55 Centennial St.  
Peaks Island  
New Residential  
Scott Braman

**CITY OF PORTLAND, MAINE  
DEVELOPMENT REVIEW APPLICATION  
PLANNING DEPARTMENT PROCESSING FORM  
Planning Department Copy**

**RE:** Site Plan Review  
Scott Braman Property  
55 Centennial Street

**SITE PLAN**  
SCALE 1:20

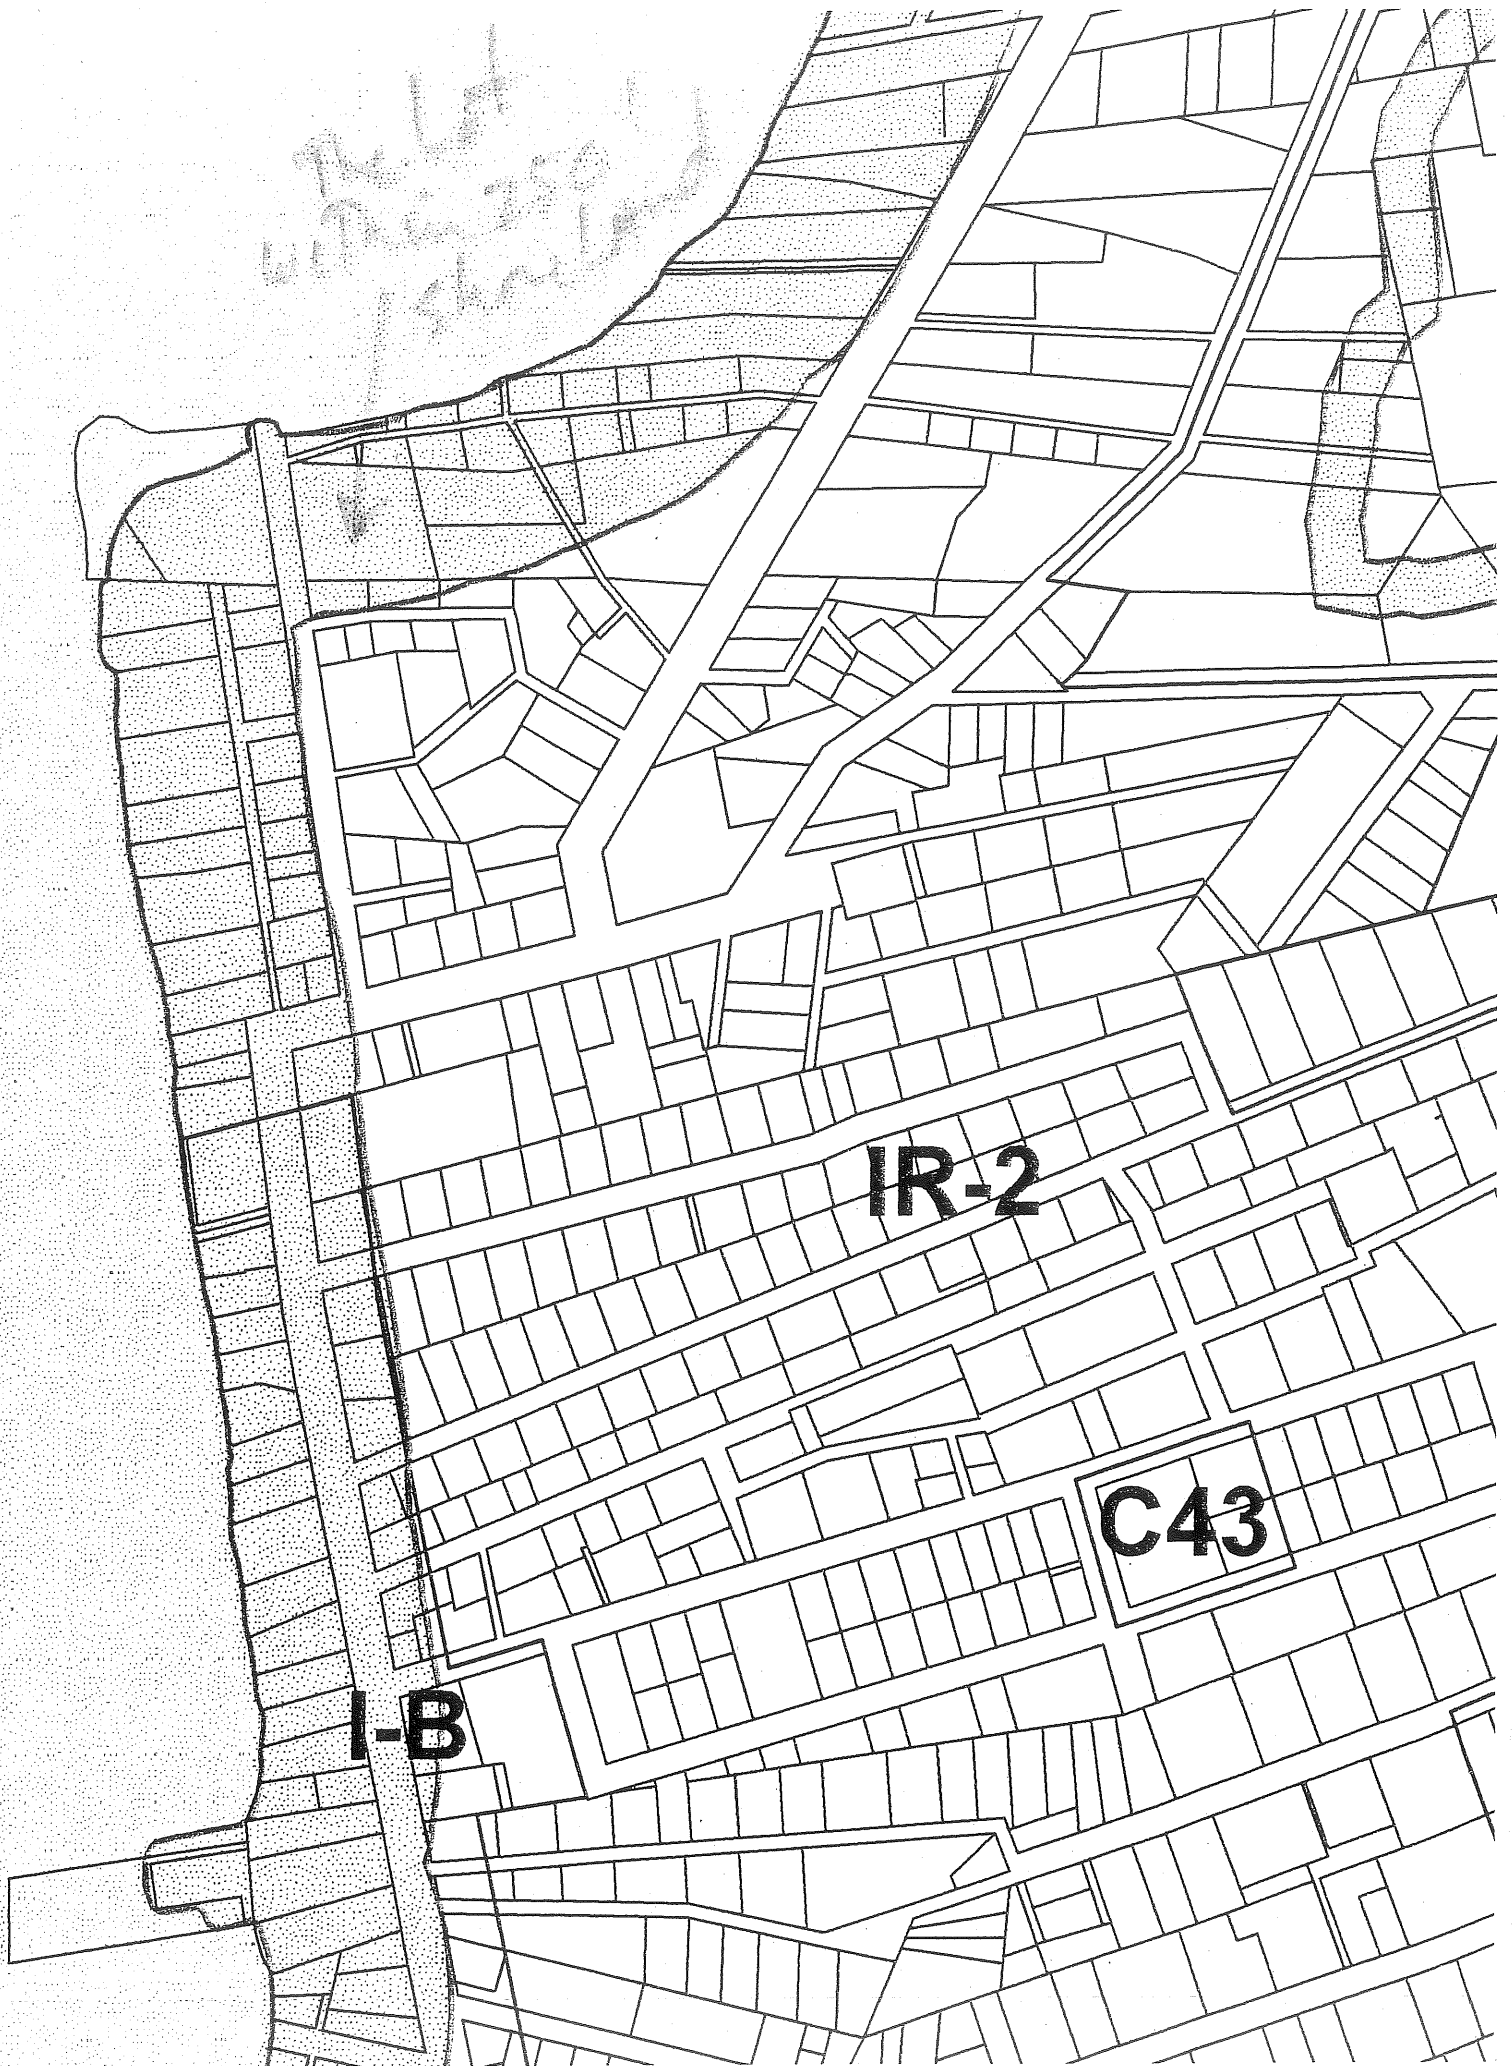
Red indicates New Deck Area & location of Foot Posts
